# Congestion Isolation Proposal Analysis

Vahid Tabatabaee (Broadcom)  
Mohan Kalkunte (Broadcom)  
Hugh Holbrook (Arista)

3/7/2018

# Review of the CI proposal

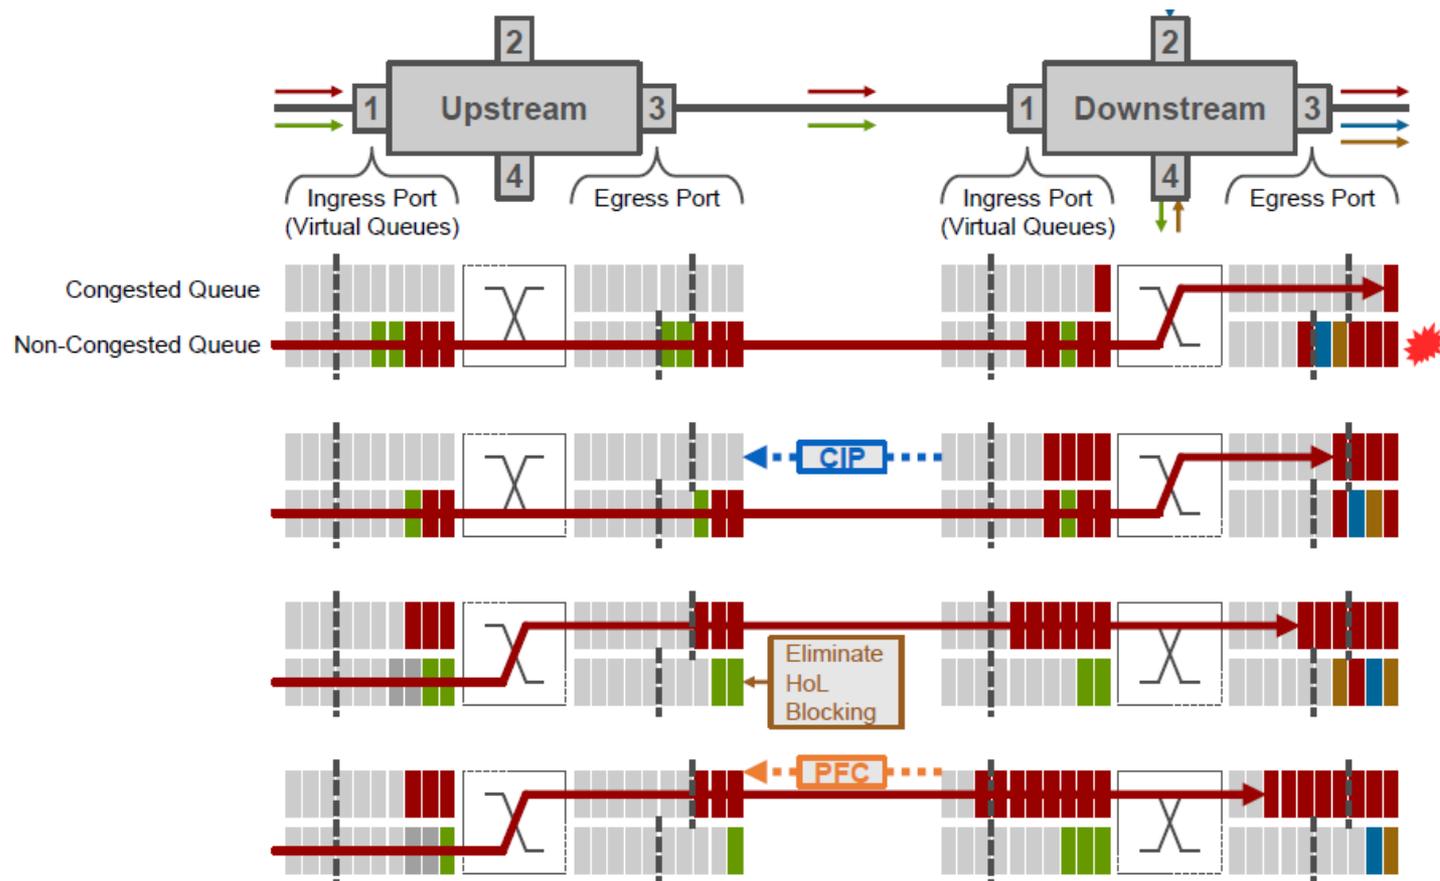
- Ineffective in controlling sudden burst of short-lived flows
  - Sampling based method does not identify short-lived flows accurately
    - Cause unfairness in throughput and latency across flows
    - Hence negatively impacting tail latency and 99% FCT
  - Latency in congested flow identification degrades effectiveness for short-lived flows
    - There is a delay in identifying and reporting congested flows to upstream node
      - First the uncongested queue should pass the threshold
      - The flow packets should be sampled
      - CIP should be transmitted and received at the upstream node
    - Short-lived flows may be finished by the time they are identified and reported
      - 100KB flow takes ~8 usec. on a 100G port

- Background
  - Congested to uncongested transition is done by using inactivity timeout
- Issues
  - Interaction with PFC
    - Congested flow packets may stay for a long time in the congested queue due to PFC-XOFF
    - Therefore, using inactivity timeout on packet arrivals does not avoid packet reordering
  - Interaction with ECN
    - A congested flow rate can be controlled and reduced by e2e congestion management
    - However, since sources use traffic pacing the inactivity timer may not timeout
    - The impact is HOL blocking of the well behaved flows

- CI proposal requires larger burst absorption buffer
  - CI works properly only if the PFC ingress port thresholds is multiple times larger than egress queue thresholds

- CI proposal requires larger headroom buffer
  - PFC can be triggered for both congested and uncongested priorities and both need reserved headroom buffer
